SERVICE BULLETIN

APPLICABILITY: Legacy, Impreza and Forester Vehicles
SUBJECT: Modification of Timing Belt Tensioner Bracket

NUMBER: 02-93-04
DATE: 11/05/04

Figure 1

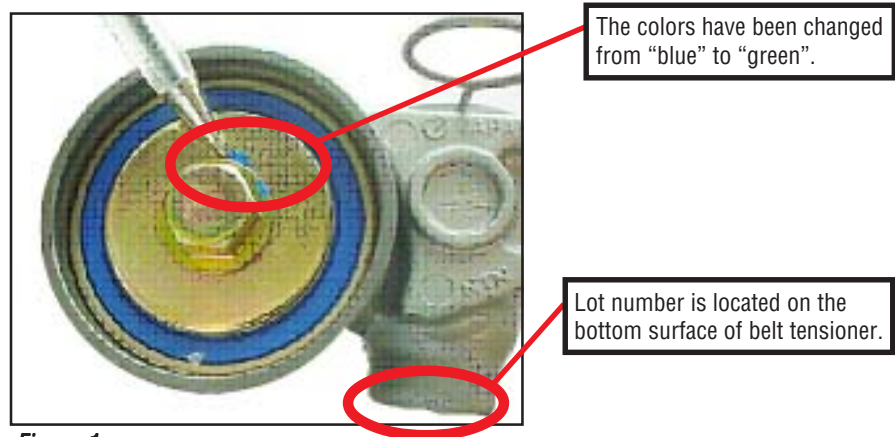
The color of the paint dot on the pulley bolt was changed from "Blue" to "Green" (see Figure 1)
Lot number of belt tensioner: 020402 and after.

Figure 2

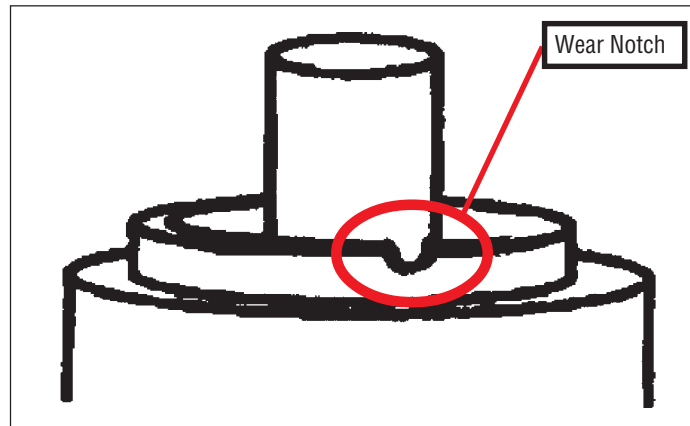
- (2) Confirm if the noise is coming from the upper portion of the timing belt tensioner by using a stethoscope. If noise can be heard it's either coming from the tensioner or bracket. Inspect the belt tensioner; if the cylinder body of the timing belt tensioner has a notch from wear (see Figure 2) the tensioner will need to be replaced.
